Groundwater Application Review Summary Form

Application # G- 19014 - REREVIEW

Date Review Completed: 01/22/2021

TO: Water Rights Section Date 01/22/2021
 FROM: Groundwater Section M. Thoma
Reviewer's Name
 SUBJECT: Application G- 19014 - RR Supersedes review of 11/12/2020
Date of Review(s)

Well Location Map

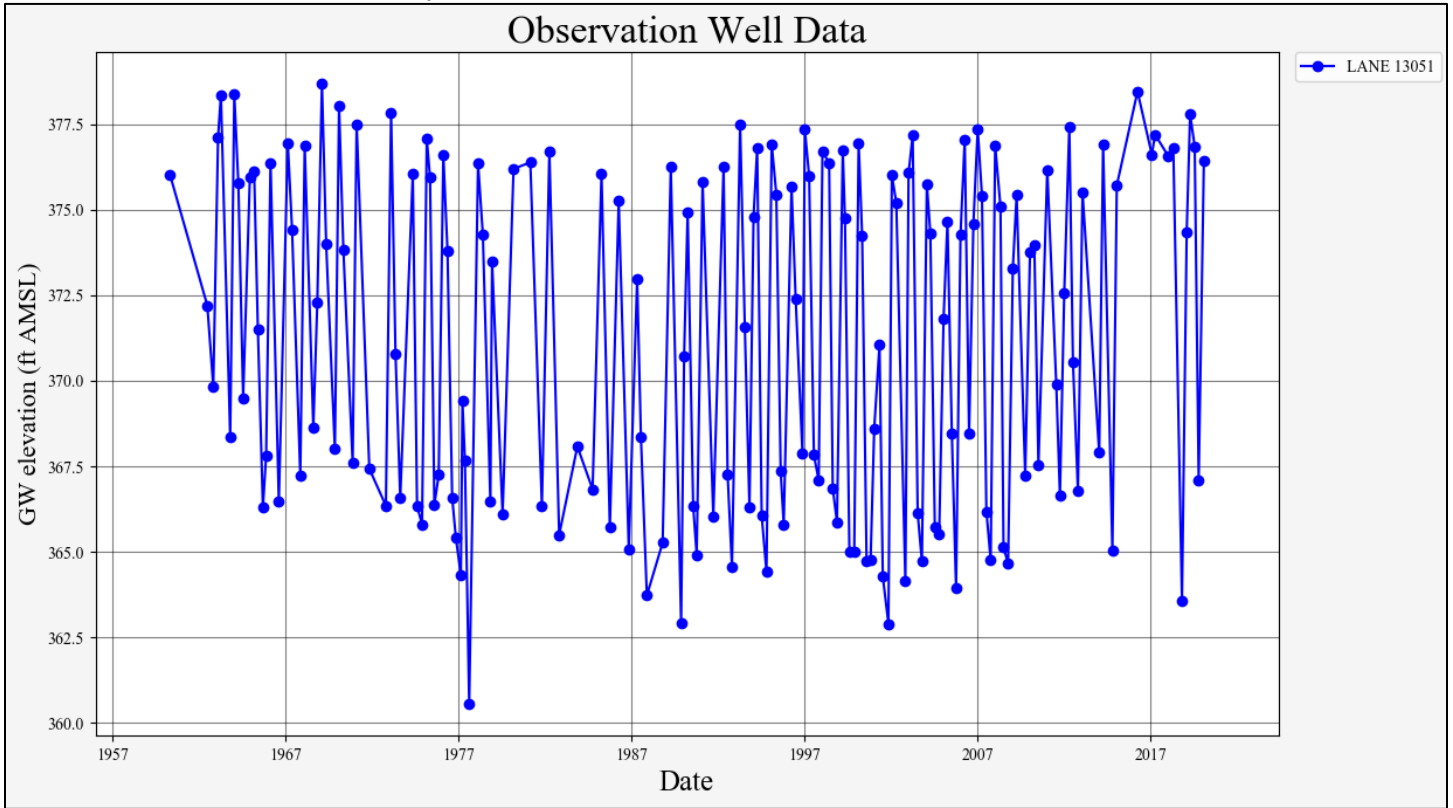
Basis for aquifer hydraulic connection evaluation: GW elevations are similar to SW elevations and the wells are producing from a shallow alluvial aquifer. Distances are taken from recent survey conducted by Will McGill Surveying LLC on 01/08/21.

Stream-Depletion Model Results

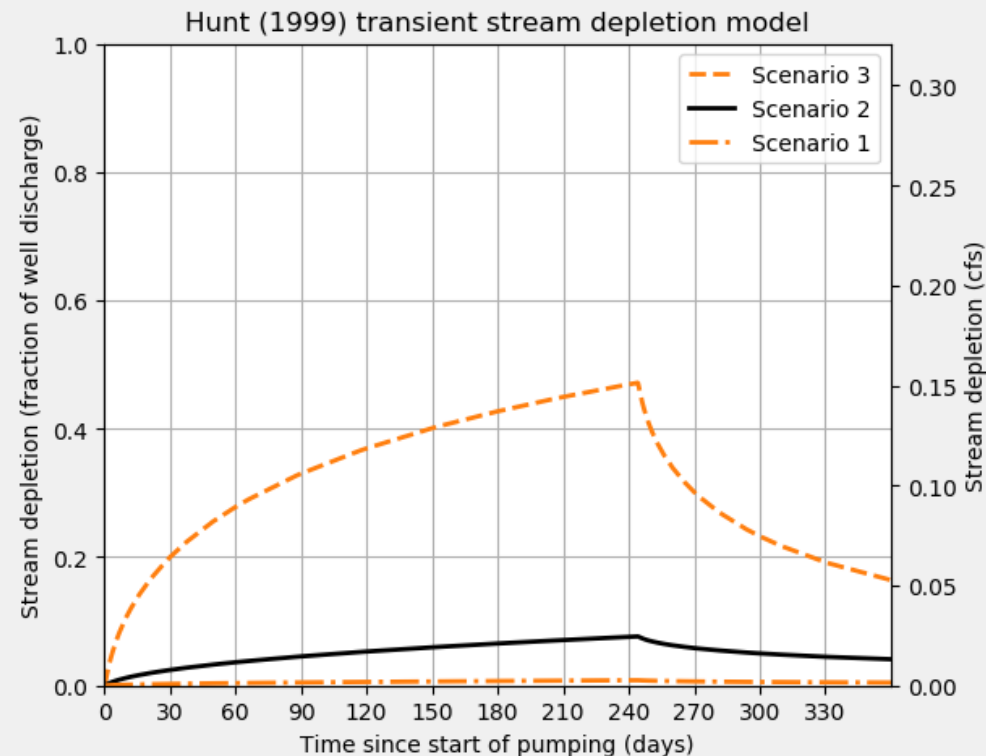
Comments: Stream-depletion was estimated using the Hunt-1999 model and a range of aquifer parameters taken from the references below and representing a range of possible values. Based on the results of this modelling, estimated stream-depletion at 30 days is likely to be less than 15% for both proposed PODs
